TRAFFIC IMPACT STUDY

Trinity Ranch

El Paso County, Colorado

PCD File No. CS252

FIGURE 5

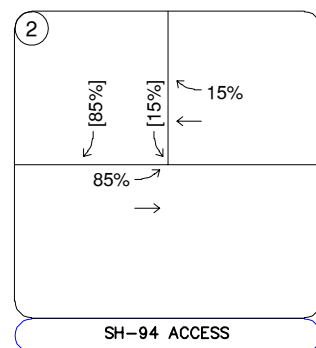
Include this intersection

Revised.

FIGURE 6

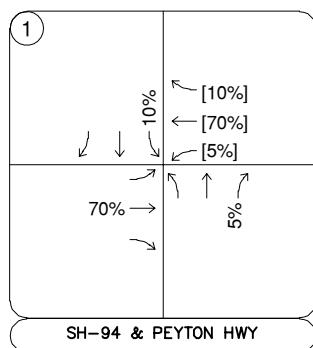
Include this intersection

Revised.

FIGURE 8

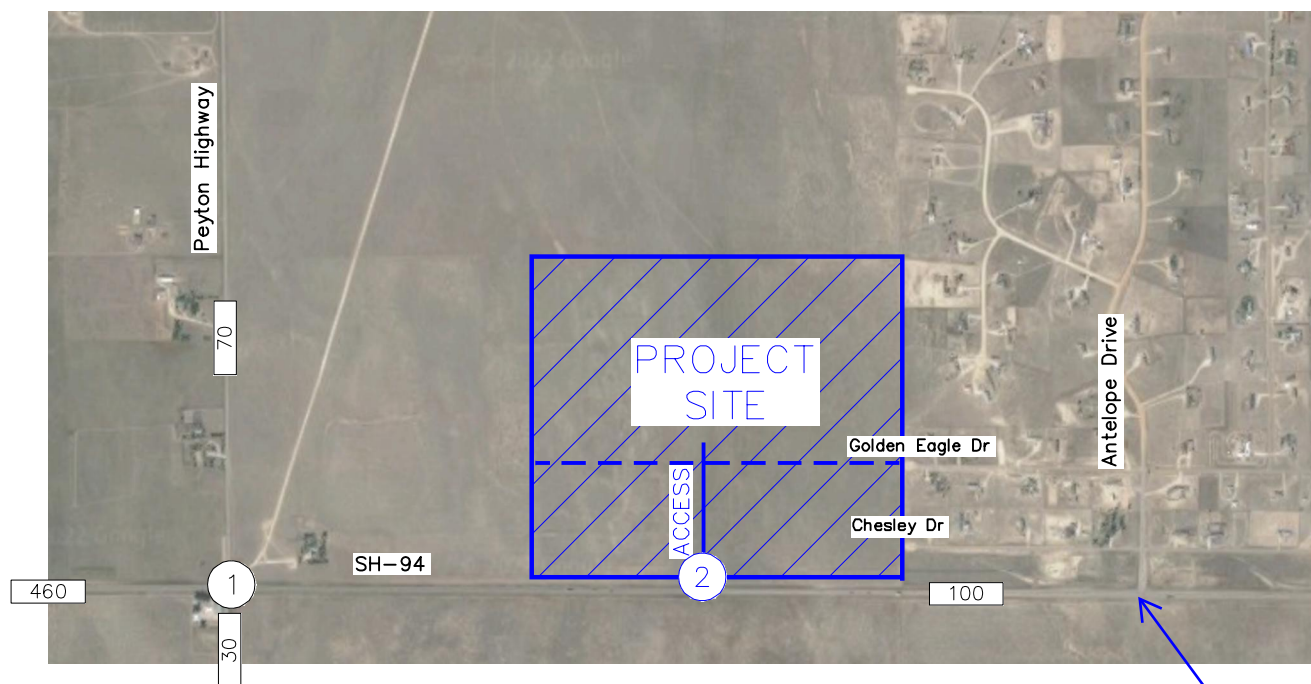
Include this intersection

Revised.

FIGURE 10

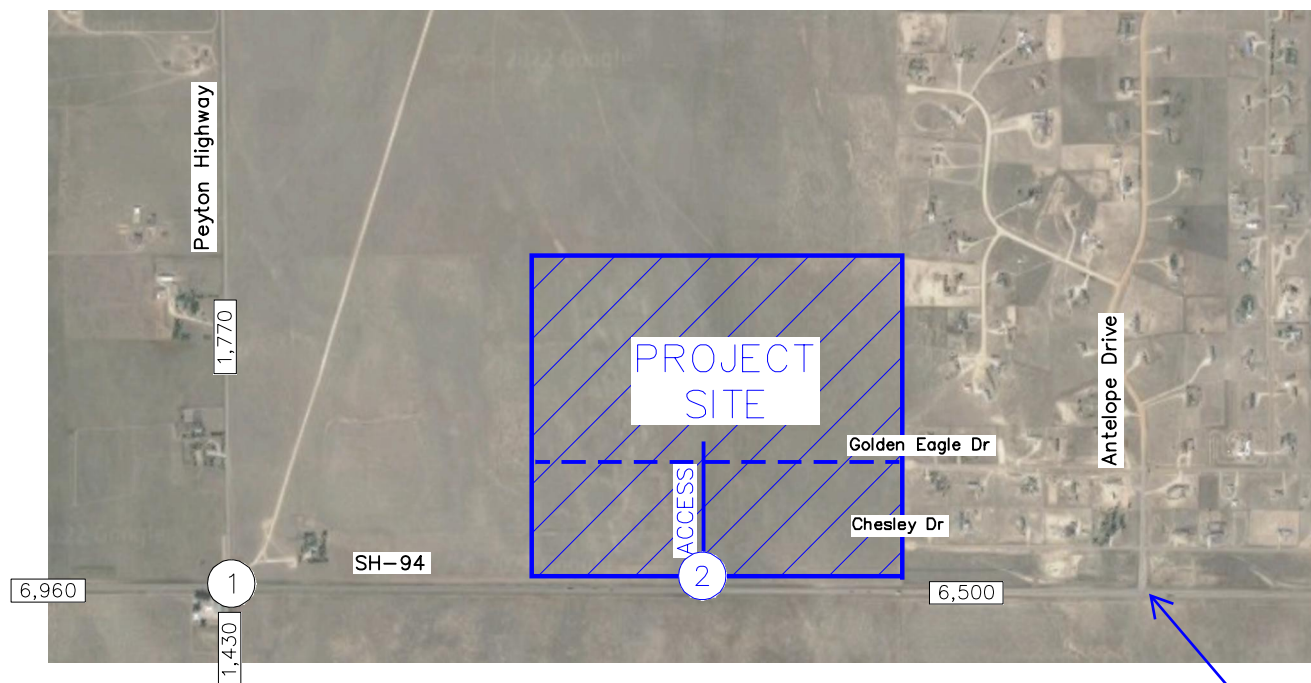
Include this intersection

Revised.

FIGURE 12

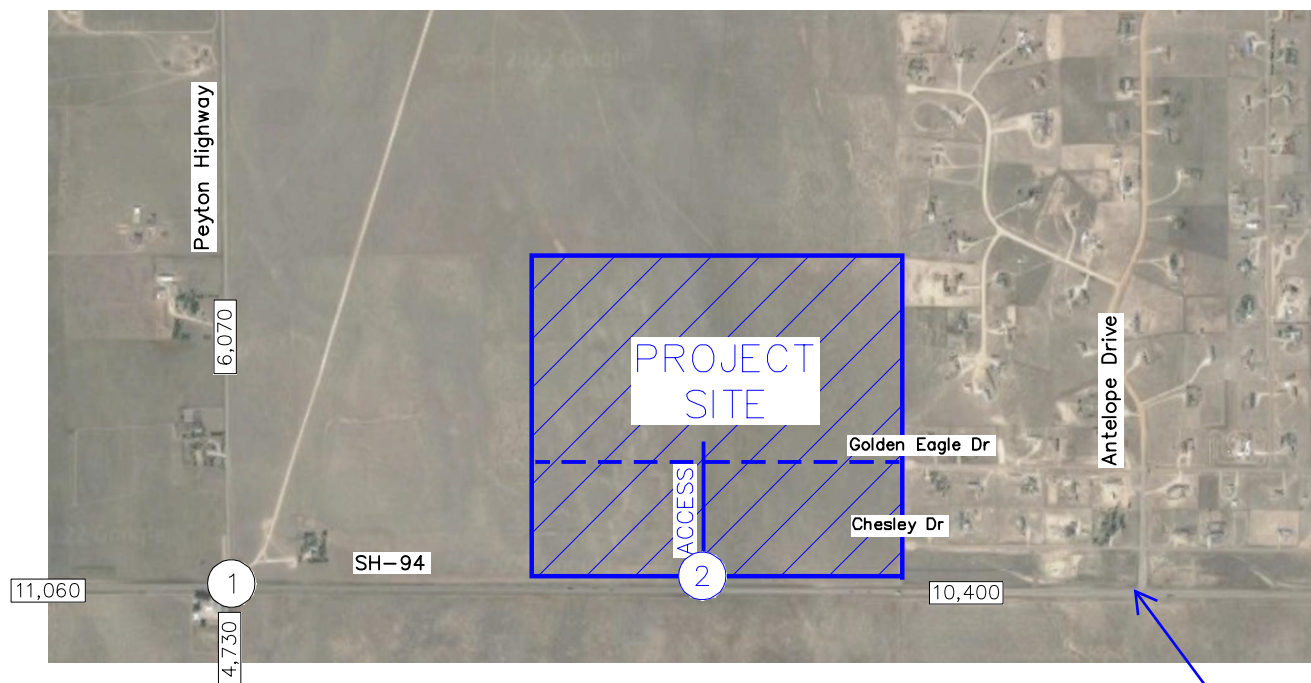
Include this intersection

Revised.

FIGURE 15

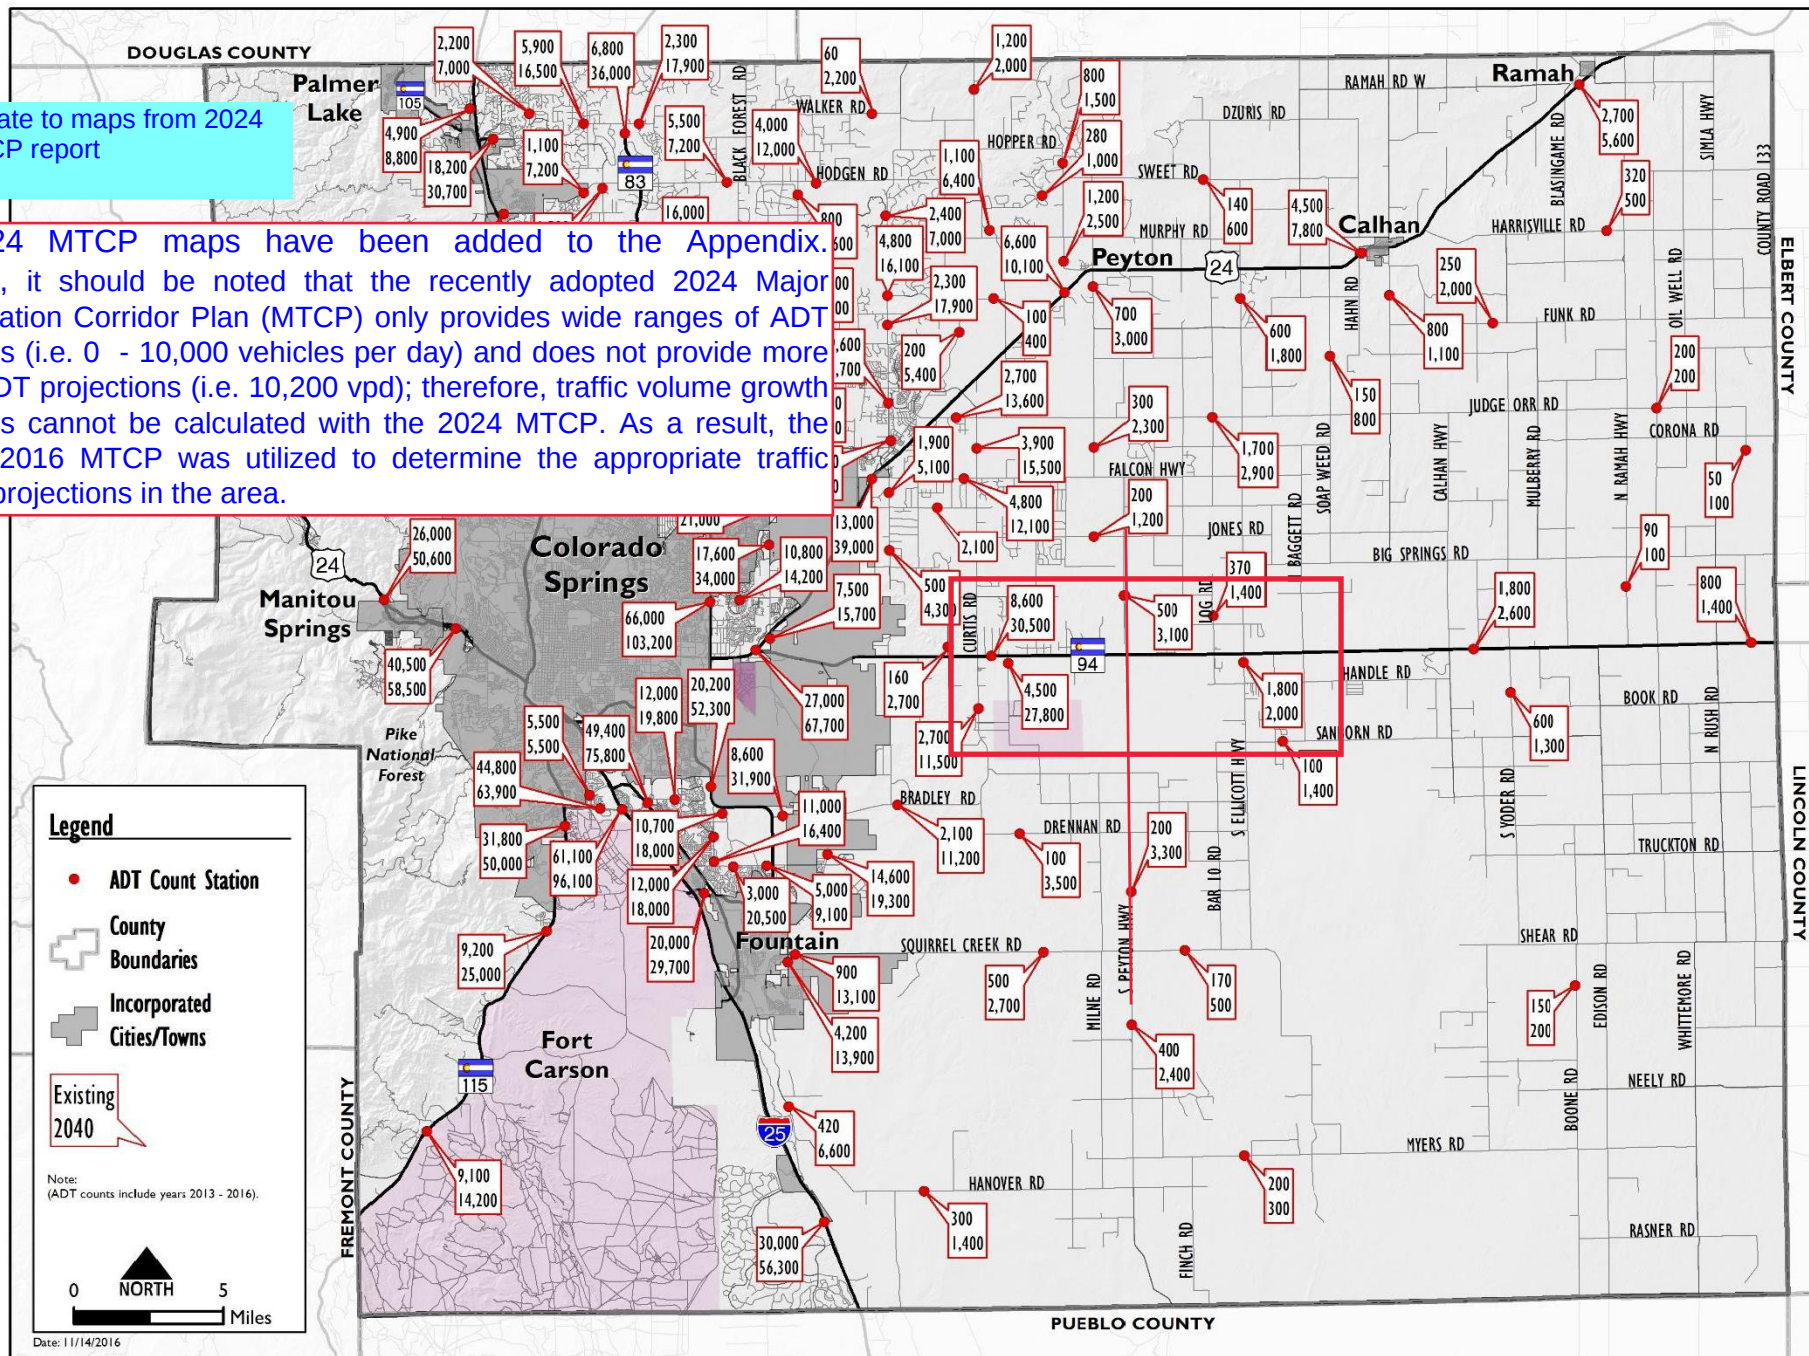
Be sure to include this intersection as this is the "main" access for Filing 1. Typical comment for following Figures as well.

2029 Rec Geo Figure has been added while SH-94/Antelope has been added to 2030 buildout and 2050 long-term recommended geometry figures.
